802.3dj Annex 174A histogram bin 16 definition

In support of comment R2-142

IEEE P802.3dj – September Interim

Probability of a test block having k errored symbols

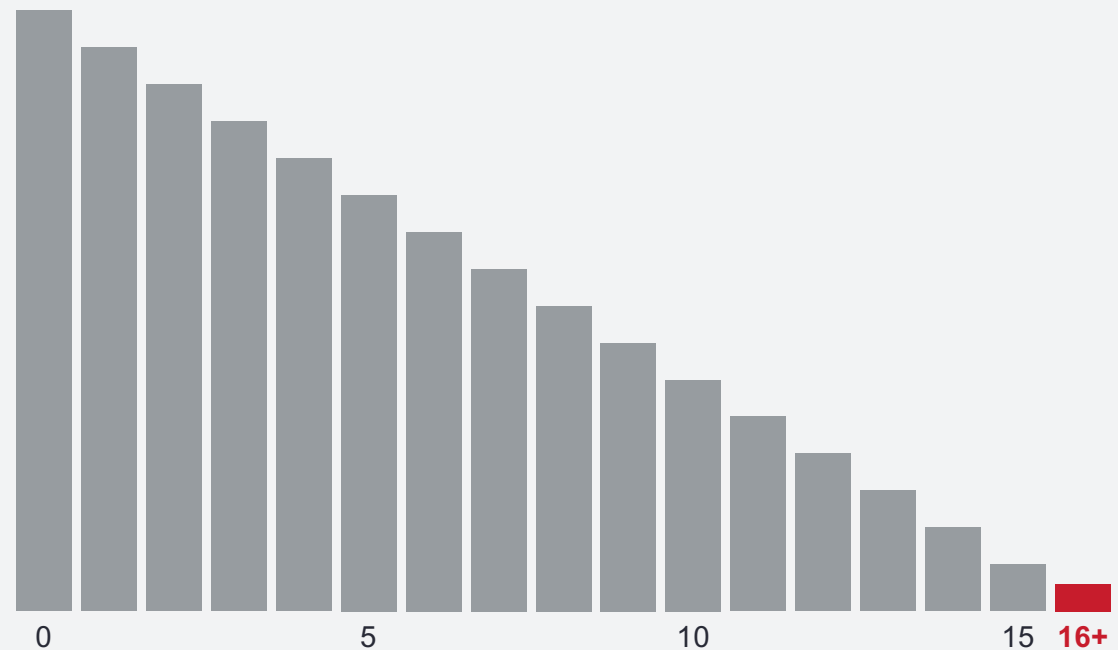
- Bins 0-15 are point probabilities; bin 16 is the accumulated tail.

Bins 0-15: exactly k errors

Bin 16: 16 or more errors, accumulated into one tail bin
